## ENGINEERING MEMORANDUM

TITLE	ADDITIONAL SUPPORT - WINDSHIELD COWL COMPASS MOUNT AS PER FIG. 1.		REF. NO. 12963	DATE 11/1/- 63
PART NO.			END PG. 1	END PG. 2
ITEM NO.			END PG. 3	END PG. 4
TYPE OF COWL	DISPOSITION ON STORE		CARRIERS STORED IN:	
COWL/SCREEN	UNFITTED	REFURBED	UNFITTED	UNFITTED
COMPONENT	REFURBED	REFURBED	REFURBED	REFURBED
ITEM GROUP/TESTES	ITEMS TESTED OR EXAMINED BY		CARRIER	
ITEM DRAWING	Y. H. L. S. AND D. W. D. A. W. P. & D. E. G.		RCAF	
REVISED DRAWINGS	PARTS IN PROGRESS		TYPE AIRCRAFT	
VARIATION	TOOKED		EDITOR	
COMPLETE NOTES	NEW DATE		AIRCRAFT INSPECTION NO.	
ITEM AS NOTED	✓	INTERMAGNETICITY TESTED	MAX. 60	TEST FLIGHT
APPENDIX	YES	NO	YES <input checked="" type="checkbox"/>	NO
NOTE: PART NUMBER AND SERIAL NUMBER UNKNOWN				
REMARKS: CARRIER WITH 67. DISPOSITION UNKNOWN.

TITLE      ADDITIONAL SUPPORT -  
              WINDSHIELD COMPASS MOUNT

E.M. No. 12963

FIG. 1

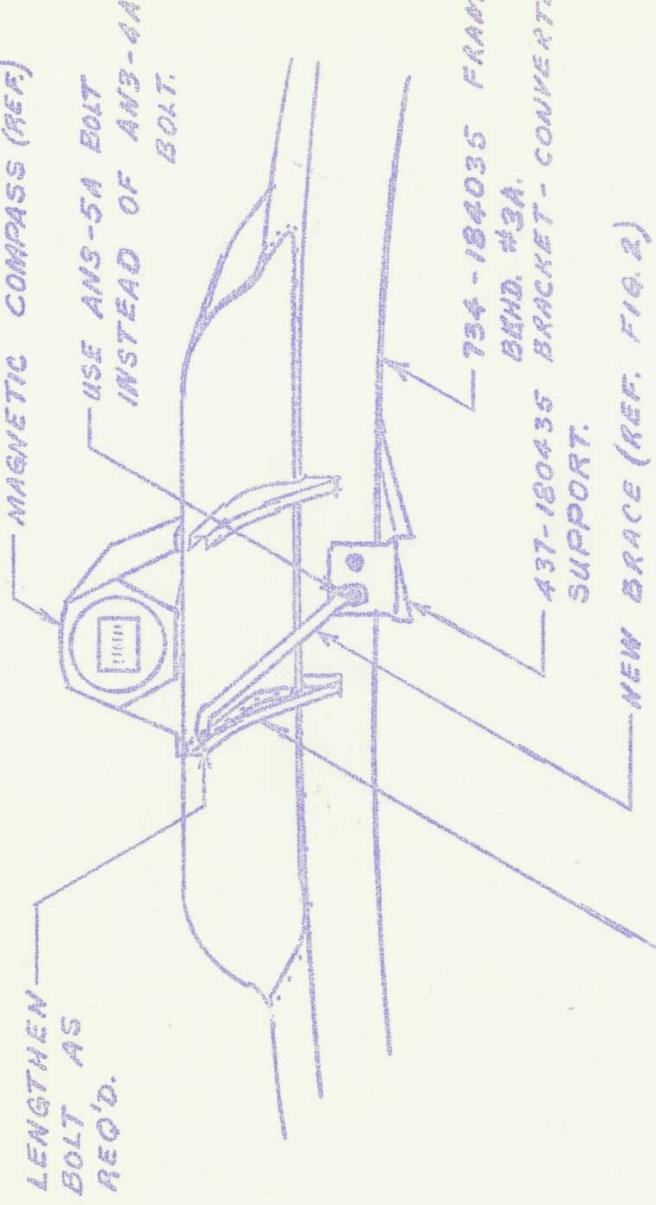
THE MAGNETIC COMPASS (RCAF REF. 6B/669)  
HAS BEEN REPORTED TO VIBRATE FREELY  
ON SOME AIRCRAFT DURING FLIGHT.

TO RECTIFY THIS CONDITION THE  
WINDSHIELD COWL IS TO BE GIVEN ADDITIONAL  
SUPPORT BY INSTALLATION OF THE BRACE, SHOWN  
IN FIG. 2, AS PER FIG. 1.

THIS INST ALLATION IS OVER TO BE  
MADE ON AIRCRAFT SNAGGED FOR EXPRESSIVE  
VIBRATION OR THE MAGNETIC COMPASS.

FIG. 2

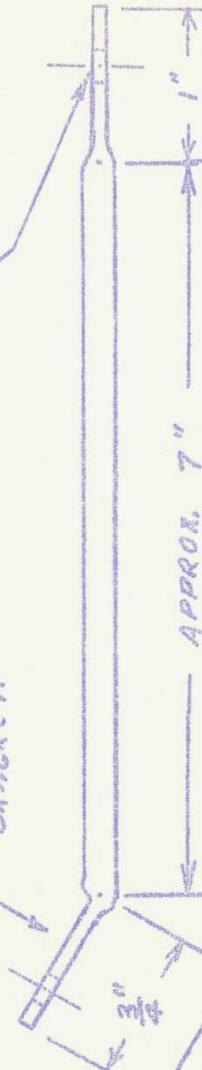
THIS END TO ATTACH TO THE 404-183752 BRACKET.

DRILL #11 (.191)  
1 HOLE TO FIT

NOTE: SEND ENDS AS REQ'D  
TO FIT.

MATERIAL:  $\frac{3}{8}$ " X .035" STS  $\frac{1}{2}$  HARD  
ALUMINUM TUBE
